Technical Bulletin

TB No. AA-12059

SUBJECT: **Aeronautical Accessories Health and Usage Monitoring System (HUMS) Kit**
P/N 429-260-001

MODELS AFFECTED: Bell Helicopter Textron Canada Limited model 429 helicopters with subject HUMS installed in accordance with STC SR09536RC-D.

FIGURE 1 – CURRENT HUMS INSTALLATION – RIGHT SDM

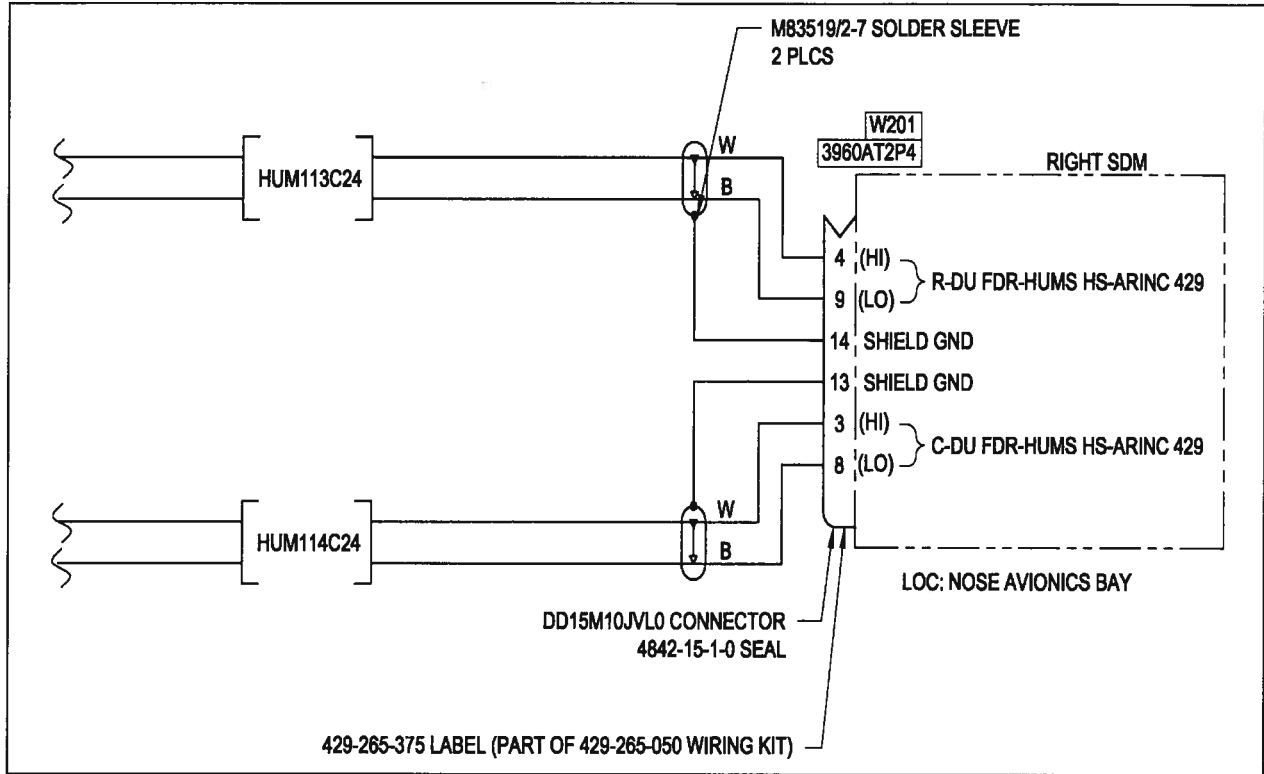
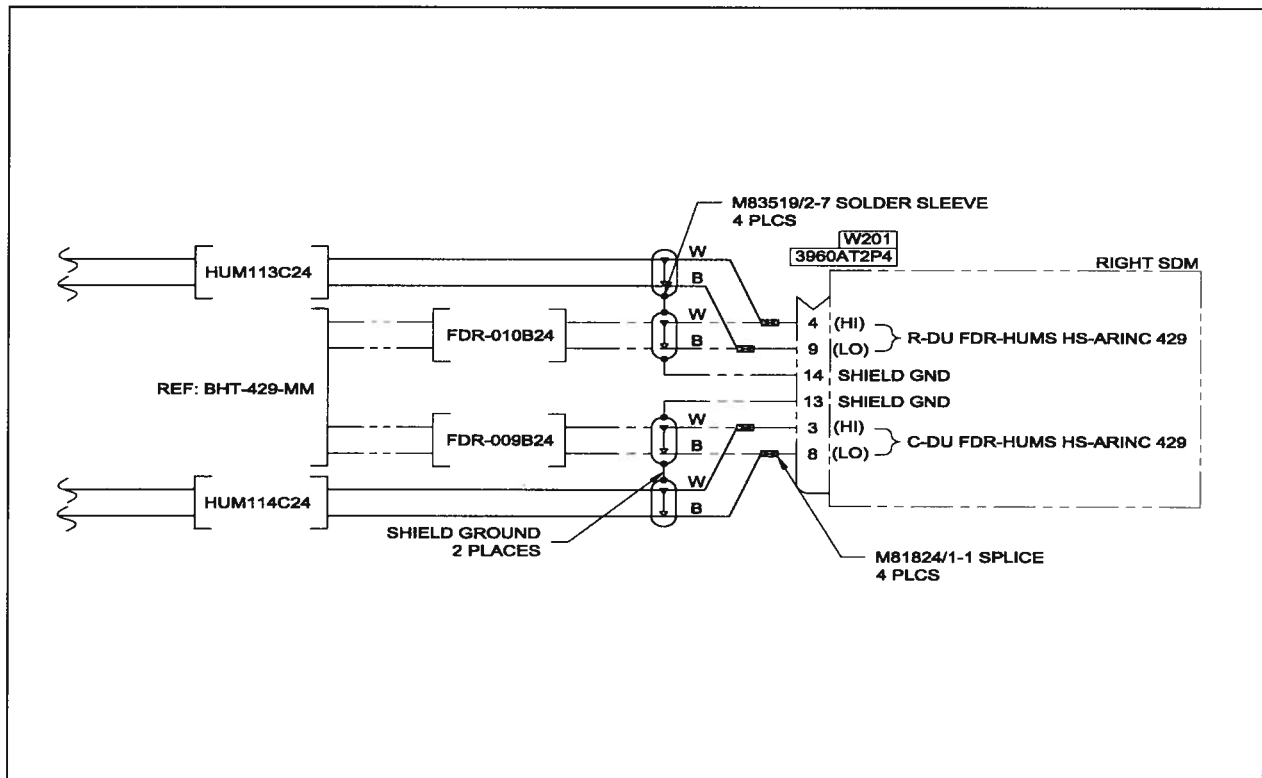
These instructions are provided to accomplish installation of CV/FDR with previously installed HUMS kit. The current HUMS installation is shown in Figure 1.

- 2.1 Ensure power is removed from aircraft.
- 2.2 Locate Right SDM Connector (3960AT2P4) in the Nose Avionics Bay, as shown in Figure 1.
- 2.3 Locate wires HUM113C24 and HUM114C24, as shown in Figure 1.
- 2.4 Depin Connector for Pins shown in Figure 1.
- 2.5 Add Solder Sleeves (M83519/2-7) and Shield Grounds to new CV/FDR wires as shown in Figure 2.

- 2.6 Splice wires into CV/FDR wiring with Splices (M81824/1-1), as shown in Figure 2.
- 2.7 Pin CV/FDR wires and Shield Grounds in Connector (3960AT2P4), as shown in Figure 2.
- 2.8 CV/FDR – HUMS Interface Installation Complete.
- 2.9 Complete CV/FDR Installation & Checkout Procedure.

Shield Grounds to be less than 6" in length and made from M22759/16-22 or equivalent wire.
